PLANNING AND ZONING COMMISSION AGENDA
MONDAY, AUGUST 10, 2015, 5:00 P.M.
191 E. SUN VALLEY ROAD, AND
480 EAST AVENUE NORTH, KETCHUM, IDAHO

Planning and Zoning Commission
City of Ketchum
Ketchum, Idaho

STAFF REPORT
KETCHUM PLANNING AND ZONING COMMISSION
REGULAR MEETING OF AUGUST 10, 2015

MAIN PLAN - REVISED

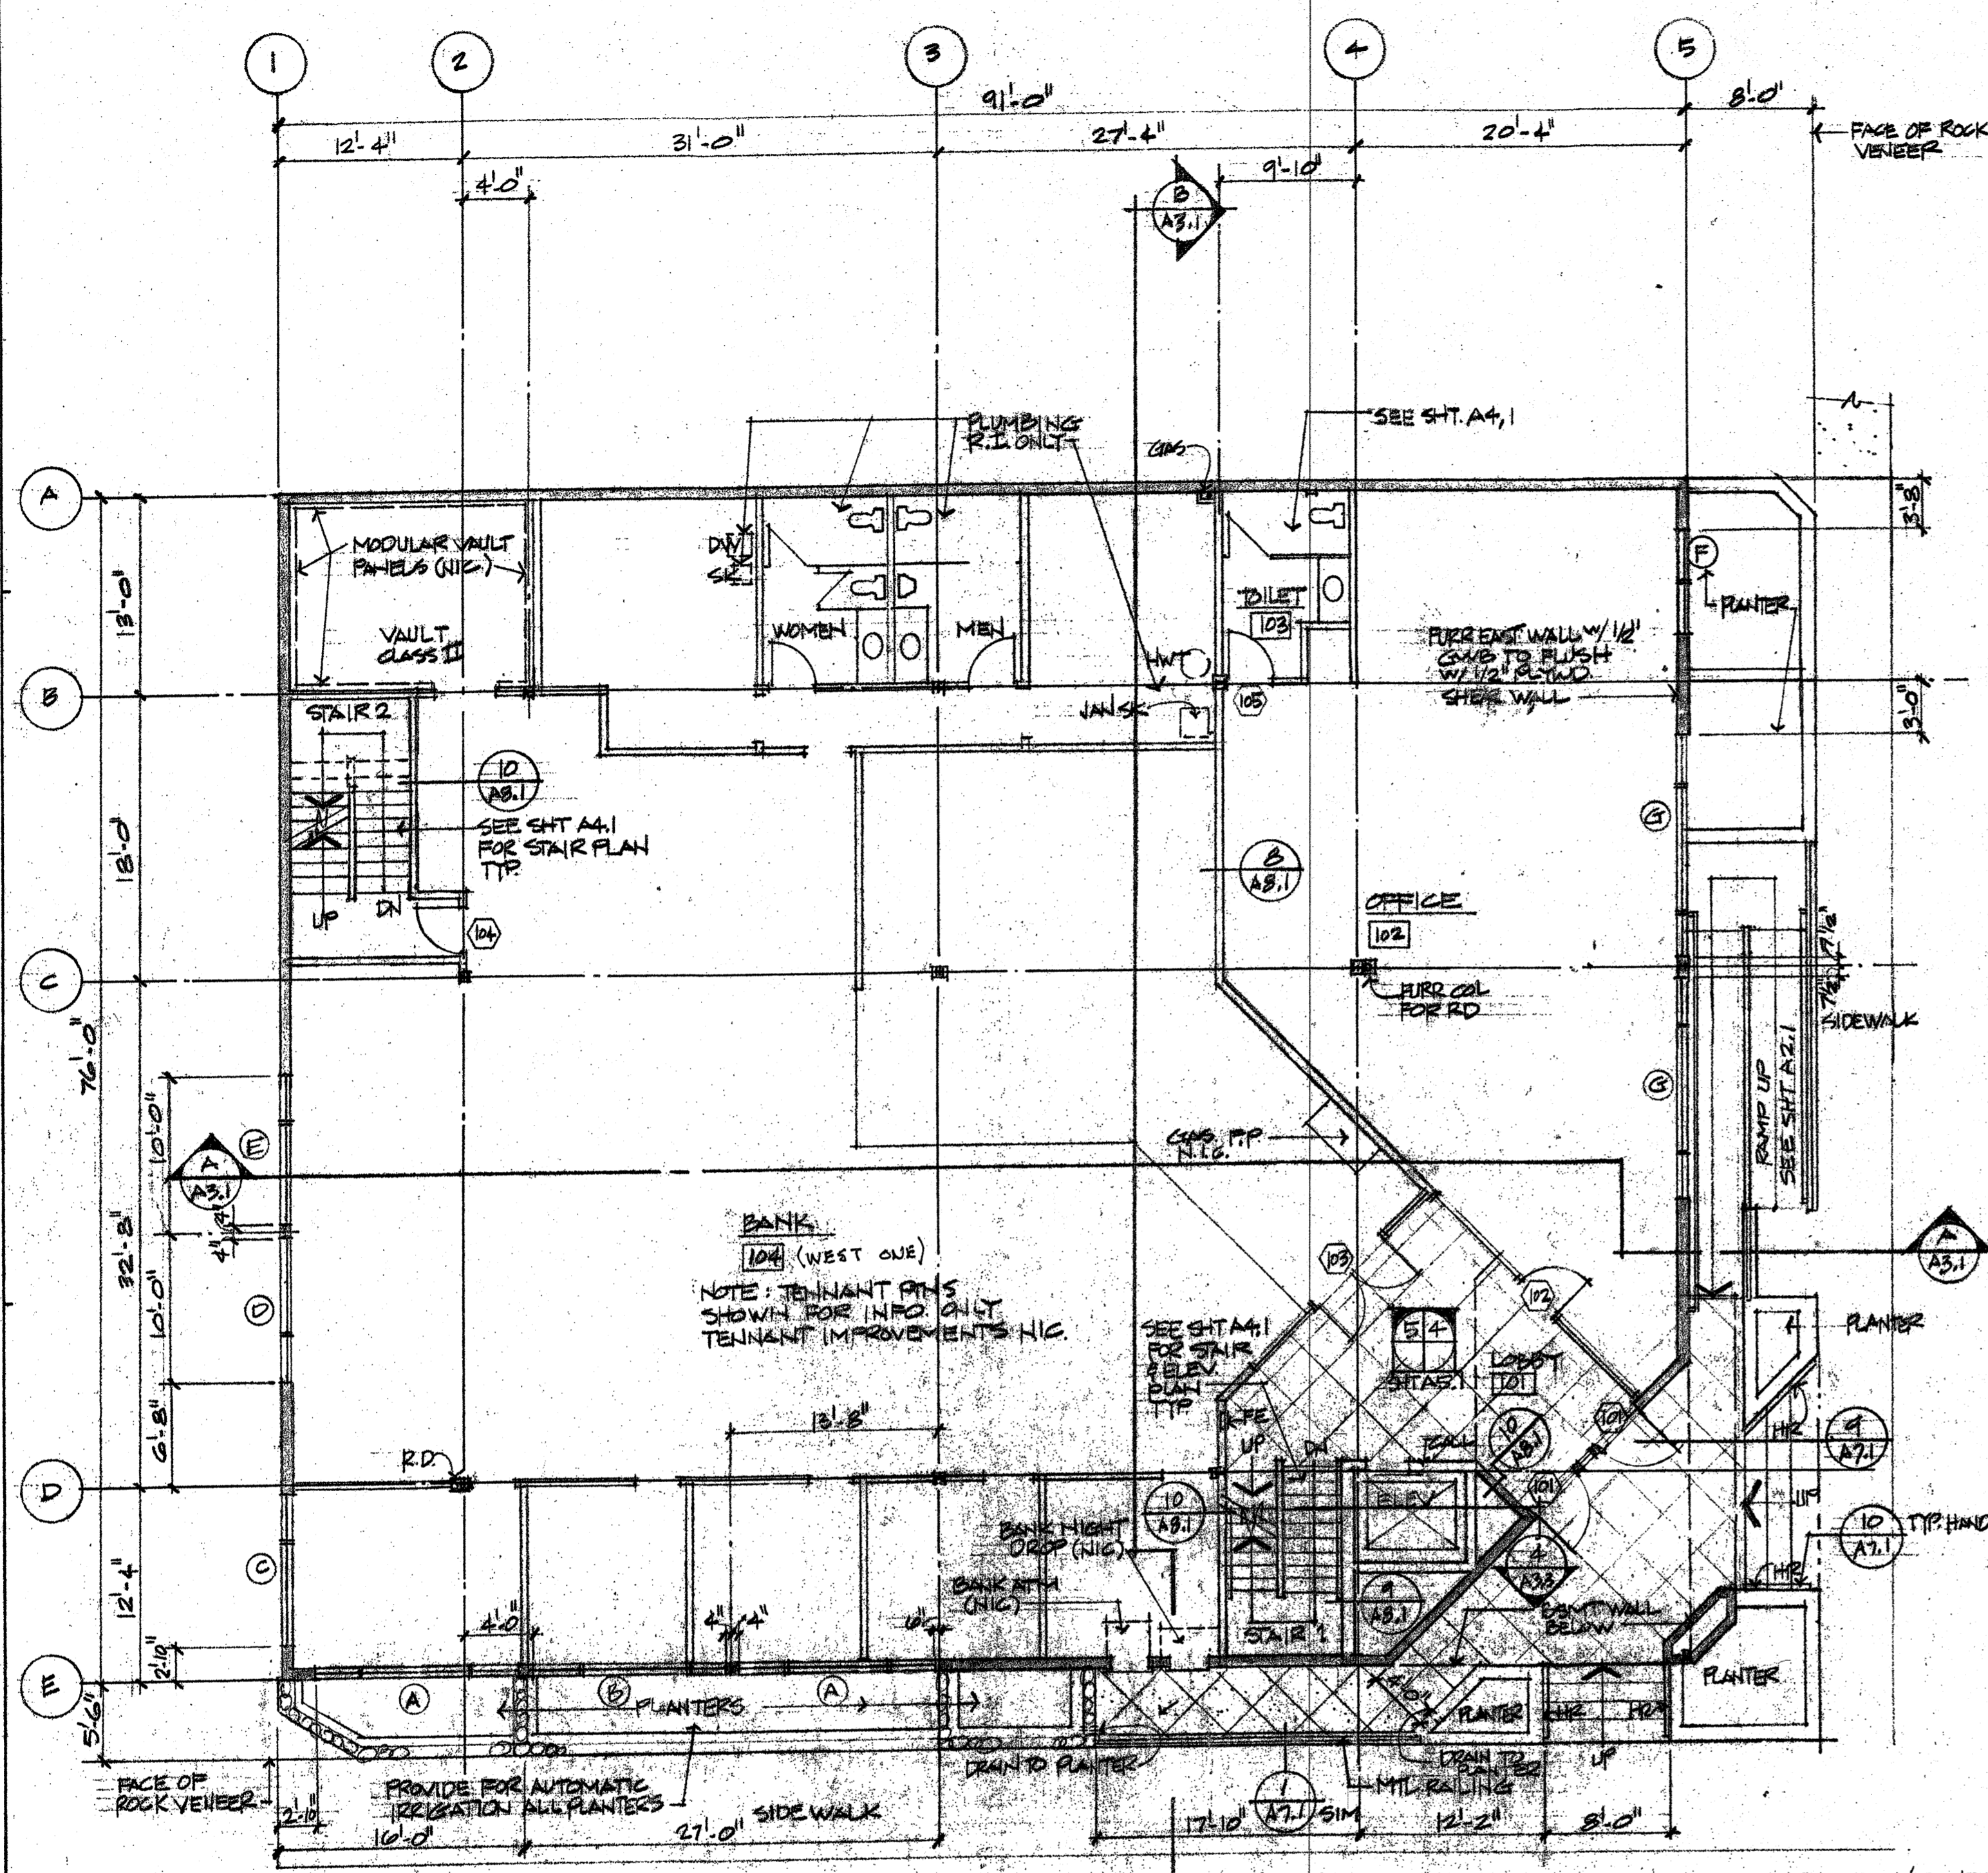
<i>Staff Comments</i>	<i>The City Arborist recommended the removal of the two street trees adjacent to the intersection. The applicant is proposing to preserve the two existing trees on Sun Valley Road.</i>
<input type="checkbox"/>	<input type="checkbox"/>	<input checked="" type="checkbox"/>	17.96.090(B)(5)d	Landscaping shall provide a substantial buffer between land uses, including, but not limited to, structures, streets and parking lots. The development of landscaped public courtyards, including trees and shrubs where appropriate shall be encouraged.
			<i>Staff Comments</i>	<i>Not applicable.</i>
<input type="checkbox"/>	<input type="checkbox"/>	<input checked="" type="checkbox"/>	17.96.090(B)(6) ENERGY DESIGN	Consideration shall be given to proper solar orientation within the project. Recognition shall be given to the solar benefits of adjoining properties. (A sun chart as a means of understanding the solar possibilities and limitations shall be encouraged)

4. All required ROW permits shall be approved prior to working within the city ROW;
5. Remove the existing planter box located at the corner of Sun Valley Road and Washington Avenue and reconstruct the curb at this intersection as approved by the Public Works Department; and
6. In addition to the requirements set forth in this design review approval, this project shall comply with all applicable local, state and federal laws.

AUG 5, 2015: REMOVE EXISTING PLANTER, SIDEWALK & CURB AT SUN VALLEY RD. & WASHINGTON AVE.
 JULY 22, 2015: MD STREET PAINTERS
 JUNE 30, 2015 (REV. CITY)
